SEYMOUR ROAD SAFETY AUDIT

Route 67 (Bank Street) & Klarides Village Drive

Exhibit 24: Recommendations

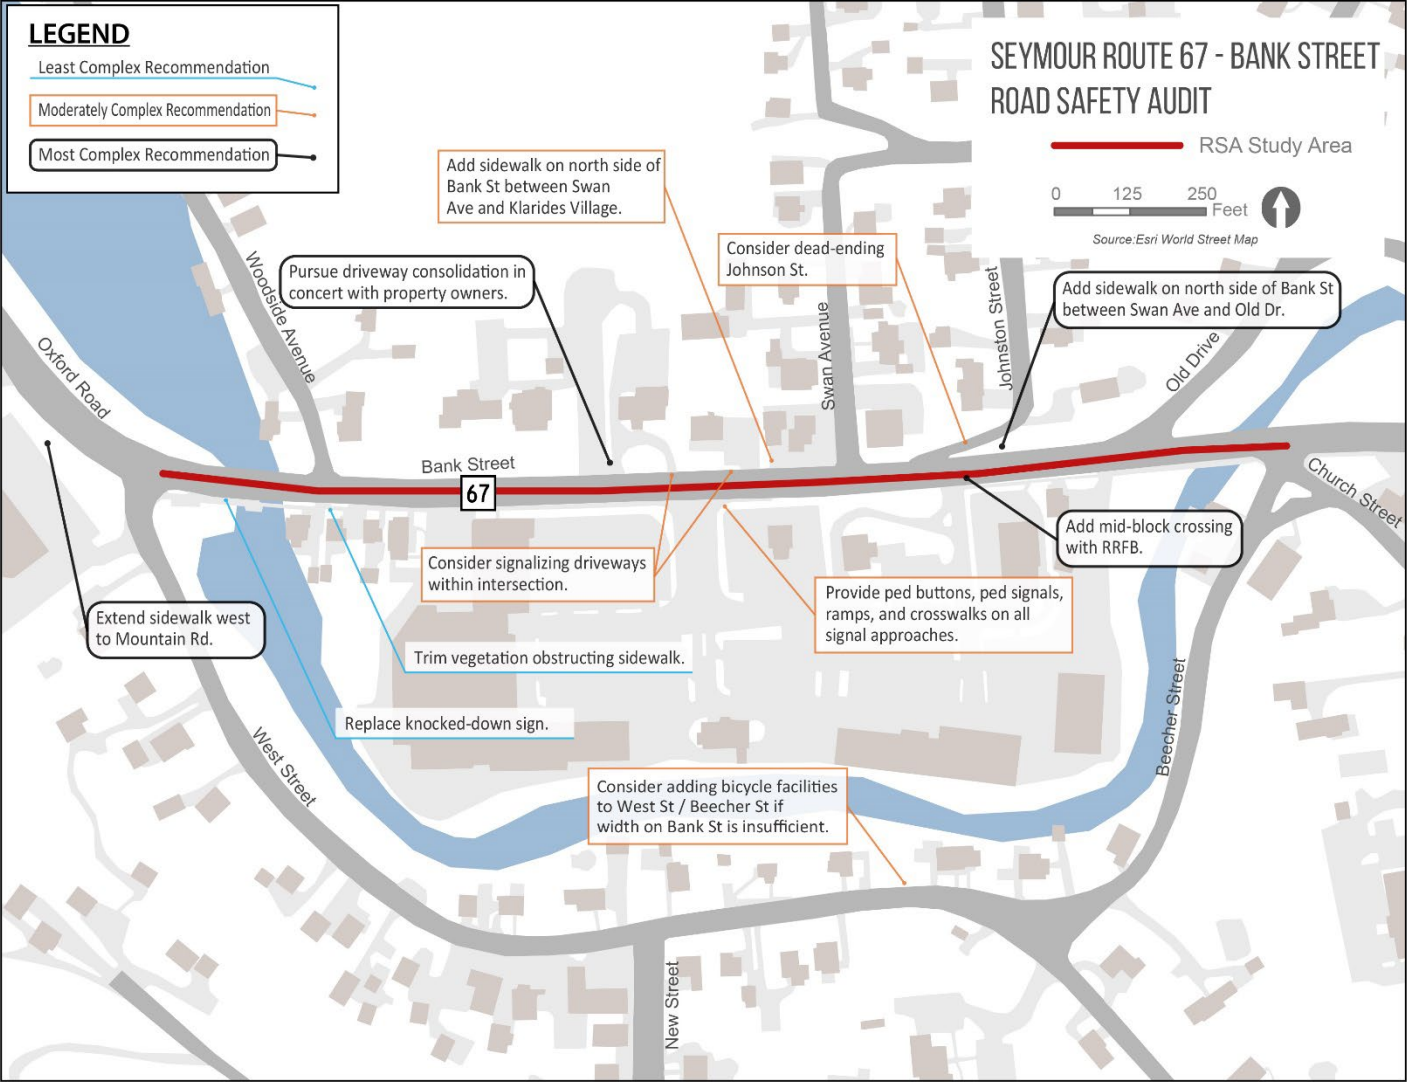
Exhibit 24 displays the recommendations of the overall study area on a map. Exhibit 26 displays a quick reference table for the recommendations in this report.

- 1) Add a sidewalk on the north side of Bank Street between Swan Avenue and Klarides Village Drive.
 - a. **Next Step:** Contact NVCOG to send request as part of the on-going Route 67 Spot Improvement construction project. The project contact can be reached at info@nvcogct.gov.

- 1) Pursue driveway consolidation with businesses on the north side of Route 67.
 - **Next Step:** Town of Seymour to concert with business owners on a driveway consolidation plan with the Miller Macari Funeral Home, Seymour-Oxford Nursery & Child Care Association, Inc. (Soncca), and counseling service.

- 1) Trim vegetation obstructing the sidewalk.
- 2) Trim vegetation obstructing the view of the speed limit sign.

- 3) Replace knocked down sign.

- 1) Re-construct non-compliant curb ramps to be ADA compliant along Route 67 to West Street.
 - **Next Step:** Contact transitionplan@ct.gov for ADA requirement or location specific clarifications and questions.

- 1) Consider adding bicycle facilities to West Street/Beecher Street if width on Bank Street is insufficient.
 - **Next Step:** Contact nvcogct.gov for potential funding sources. Check available ROW.

- 2) Extend sidewalk west to Mountain Road.

- 1) Trim vegetation obstructing the sidewalk.
 - **Next Step:** Contact property owners at Klarides Village to request maintenance of overgrown areas.

- 1) Consider dead-ending Johnson Street.
 - **Next Step:** Contact info@nvcogct.gov for potential funding sources. Town of Seymour to investigate feasibility.

- 1) Add sidewalk on the north side of Bank Street from Swan Avenue to Old Drive Road with special consideration of the retaining wall, utility poles and ROW impacts.
 - **Next Step:** Contact NVCOG to send request as part of the on-going Route 67 Spot Improvement construction project. Project contact is info@nvcogct.gov.

- 2) Consider adding a high visibility crosswalk with lighting to the Johnson Avenue intersection crossing Route 67. A high visibility crosswalk with lighting is displayed in Exhibit 25.
 - **Next Step:** Contact NVCOG to send request as part of the on-going Route 67 Spot Improvement construction project. Project contact is info@nvcogct.gov. The Town can also apply for a Safe Streets and Roads for All (SS4A) grant through NVCOG for the installation of an RRFB.
 - For new crosswalk locations, have the LTA contact DOT.TrafficEngineering@ct.gov. If the location is approved by CTDOT, the Town may pursue a high visibility crosswalk with lighting via the Encroachment Permit process.
 - CTDOT EB-2024-1 requires roadway lighting at all new pedestrian crosswalks across state roads, in conformance with the Engineering & Construction Directive ECD-2023-8.

- 1) Add crosswalk markings to the Old Drive intersection connecting landing pads on Route 67 and Old Drive.

- 1) Add sidewalk on the north side of Bank Street from Old Drive Road to Swan Avenue.
- **Next Step:** Contact NVCOG to send request as part of the ongoing Route 67 Spot Improvement construction project. Project contact is info@nvcogct.gov.
